E4417A-15

S E R V I C E N O T E

E4417A EPM-P Power Meter

Power Meter Display Shrink

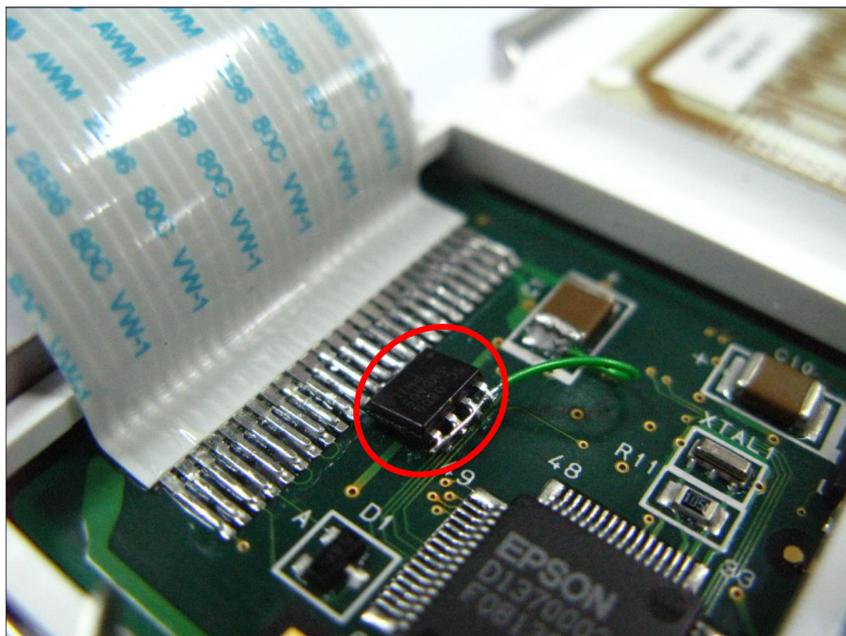
Due to some issues with the implementation of new LCD display controller in the power meter's display, intermittent display shrink is observed when operating the power meter. This however doesn't impact all the units. The display shrink scenario may look like something shown below:

To resolve this problem, replace the front panel assembly with a good one. A good front panel has additional Transient Voltage Suppress (TVS) diode soldered on it as shown below. Additional of TVS diode will prevent the display shrink from happening.
